Memorandum

Project #: 14867.01

Re: Traffic Impact and Access Study - Response to Comments

VHB has reviewed the comment letter from Nitsch Engineering, dated November 7, 2025, related to the Traffic Impact and Access Study (TIAS) assessing the CFS-3 and CSF-4 developments combined in Devens, MA presented to the Devens Enterprise Commission. This memorandum summarizes the comments made by Nitsch Engineering on their review of the TIAS and provides a response to each outstanding comment, where required.

Figure 4: 2025 Existing Conditions Weekday Evening Peak Hour Vehicle Volumes

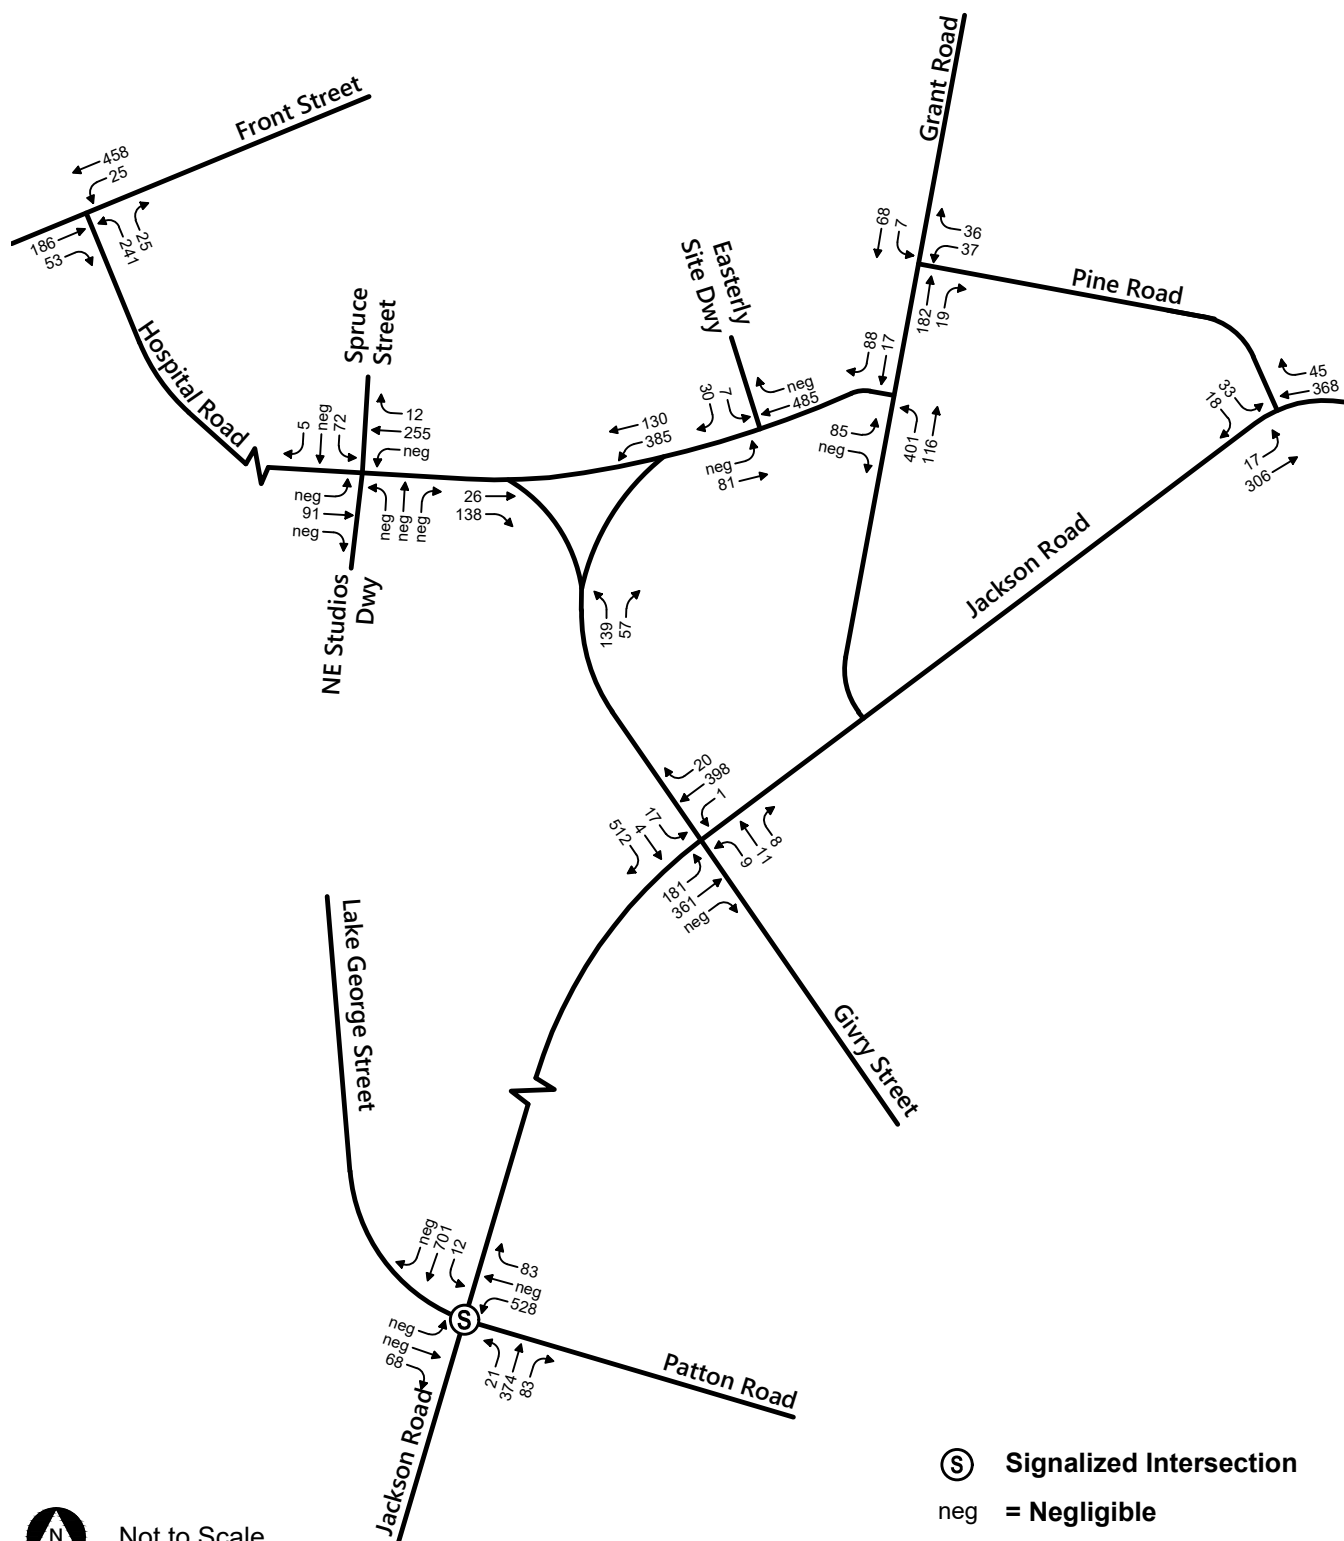
Nitsch Engineering Comment #6: *In Figure 4, Nitsch notes the southbound through volume on Jackson Road at Givry Street is stated as 9 vehicles, which is consistent with the TMC counts but is very low and does not balance with the through volumes on Jackson Road arriving and departing the intersections of Jackson Road at Pine Road to the north and Jackson Road at Lake George Street/Patton Road to the south. We acknowledge that several driveways exist that could contribute to the imbalance; however, we request the Applicant clarify if this volume is correct, and, if applicable, provide the revised volume, and updated traffic operations and safety analysis if needed.*

VHB Response: This appears to be an anomaly in that particular count. VHB reviewed previous count data for this intersection and made adjustments to the southbound movement. The revised volumes and analyses are provided in the Attachments.
